RE: SUB 2000-43 -- Final Plat of King's Maple Street Second Addition

RE: SUB 2000-43 -- Final Plat of King's Maple Street Second Addition

CASE NUMBER: SUB 2000-43 -- KING'S MAPLE STREET SECOND ADDITION

SUB 2000-43 -- Revised One-Step Final Plat of KING'S MAPLE STREET SECOND ADDITION
March 21, 2002 - Page 3

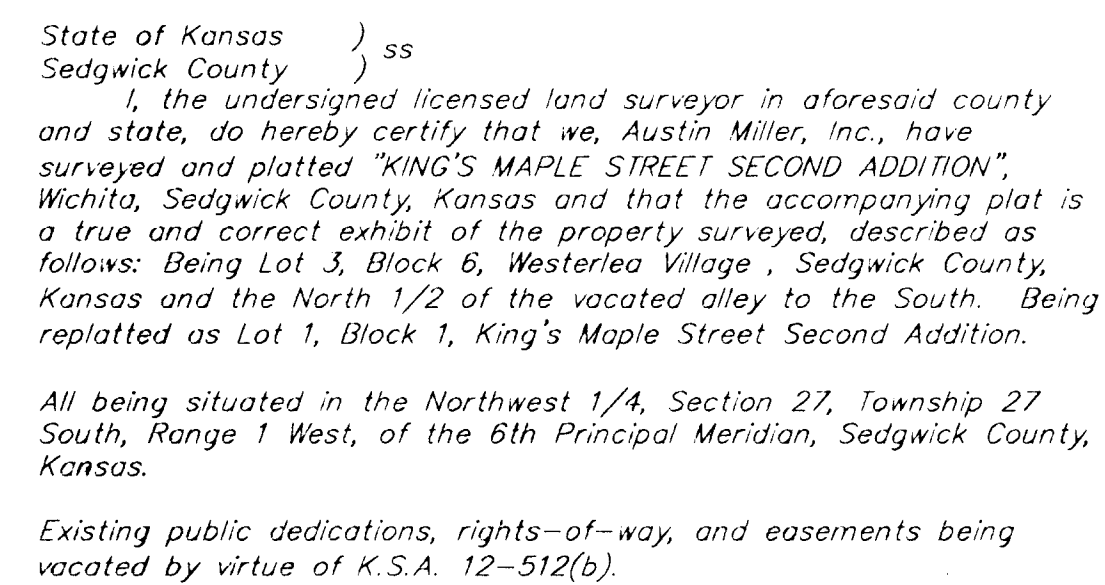
- A. Municipal services are available to serve the site. City Engineering needs to comment on the need for any guarantees or easements. No guarantees are required.

- C. City Engineering needs to comment on the status of the applicant's drainage plan. An off-site drainage agreement is needed.
- D. Dedication of access control except for one opening along the frontage of Ridge Road was required by Protective Overlay #63 associated with Z-3350; however this plat and the abutting plat to the south (King's Maple St. 3rd) indicates a total of two openings. MAPD recommends a joint opening be denoted along the south line of the plat and 150 feet of complete access control dedicated from the intersection. In accordance with the Subdivision regulations, any access openings located within 250 feet of the intersection of Maple and Ridge Road are limited to right-turns only, and shall be referenced on the face of the plat; or a guarantee provided for the future construction of a raised medial. The Subdivision Committee has approved a joint opening located along the south line of the plat.

- G. **Traffic Engineering** needs to comment on the need for the dedication of any additional right-of-way. The plat indicates a "corner clip" with a 60-ft half-street right-of-way in lieu of the standard 75-ft major street intersection. The street right-of-way is approved.

- M. On the final plat, the MAPC signature block needs to reference "J.D. Michaelis, Chair".
- N. The legal description needs to be corrected.
- O. The platlor's text shall include language that a drainage plan has been developed for the plat and that all drainage easements, rights-of-way, or reserves shall remain at established grades or as modified with the approval of the applicable City or County Engineer, and unobstructed to allow for the conveyance of stormwater.

A 5-ft sidewalk easement within
A 10-ft utility easement is required
(per Traffic Eng.)

- W. The representatives from the utility companies should be prepared to comment on the need for any additional utility easements to be platted on this property. *Southwestern Bell has advised that overhead facilities are located within existing easements. Said easements need to be maintained, or the applicant shall pay costs to relocate the cables.*
